Access Compliance Report

Public Rights-of-Way

(Curb Ramps)

Intersection ID: 15215	Main Street: HARRISBURG_RD	Cross Street: OLD_MEADOW_RD	Location: NW
ADA ID: 02BB96C12AC5	Ramp Type: Perp	Initial Pass/Fail: Fail	Overall Compliance: No
		Severity Score: 25

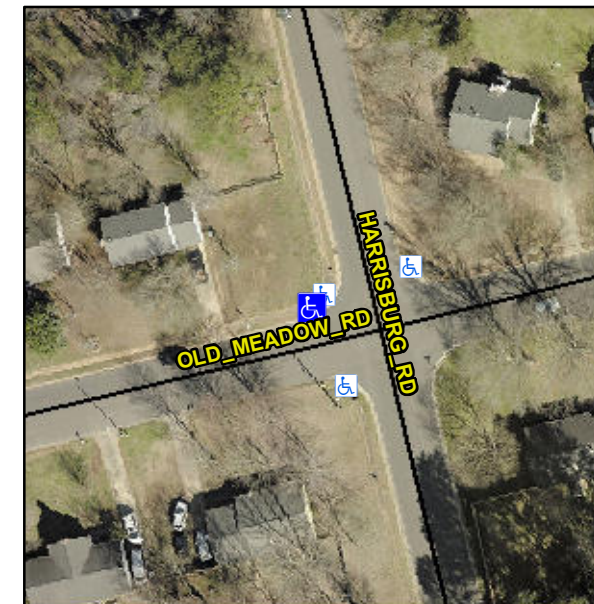
R304.2.2, R304.5.3

Compliance	Description	Data	Compliance	Description	Data
N/A	Ramp Length (in)	78.0	No	Ramp Slope (%)	10.0
Yes	Ramp Width (in)	48.0	No	Ramp XSlope (%)	5.9
N/A	Flare Type LT	N/A	N/A	Flare Type RT	N/A
N/A	Flare Slope LT (%)	N/A	N/A	Flare Slope RT (%)	N/A
N/A	Flare Traversable LT?	N/A	N/A	Flare Traversable RT?	N/A
N/A	Landing Length (in)	N/A	N/A	DWS Provided?	N/A
N/A	Landing Width (in)	N/A	N/A	DWS Contrast?	N/A
N/A	Landing Slope (%)	N/A	N/A	DWS Length (in)	N/A
N/A	Landing X Slope (%)	N/A	N/A	DWS Full Width?	N/A
N/A	Landing Curb? (Y/N)	N/A	N/A	DWS Offset (in)	N/A
N/A	Shared Landing?	N/A			
N/A	Gutter Ponding?	N/A	N/A	Gutter Slope (%)	N/A
N/A	Gutter Lip Ht (in)	N/A	N/A	Gutter X Slope (%)	N/A
N/A	Painted X Walk1?	No	N/A	Painted X Walk2?	N/A
	X Walk 1 Direction	To S		X Walk 2 Direction	N/A
N/A	X Walk 1 Width (in)	N/A	N/A	X Walk 2 Width (in)	N/A
	X Walk 1 Slope (%)	3.1		X Walk 2 Slope (%)	N/A
	X Walk 1 X Slope (%)	3.0		X Walk 2 X Slope (%)	N/A

Remove & Replace Entire Ramp.
